Request for Advice - EIS - Kemps Creek Data Centre SSD-10101987 at No. 707 – 769 Mamre Road Kemps Creek

The following review advice is provided for the Department's consideration in relation to its assessment of the application.

Figure 3: Example of busy façade. Source applicant’s EIS

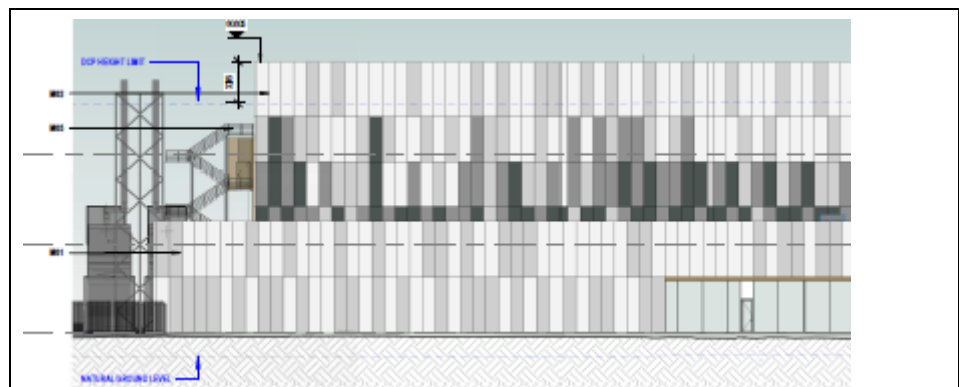
The building arrangement and architectural form provides elongated buildings with minimal varying of materials. The elevations utilise colour as the only form of articulation.

This is not sufficient and is not resolving related issues of bulk and scale.

The multiple small panels with differing colours increase the bulk and scale of the buildings. Colour patterns must be provided over larger areas of each building and are not to be provided in archaic small patches, which is creating busy and confused elevations.

Appreciating the use is a data centre, embellishment into the architectural form should be encouraged to ameliorate the overall mass and repetition of the building as viewed from the streetscape. The materiality mix must be further resolved and elevated.
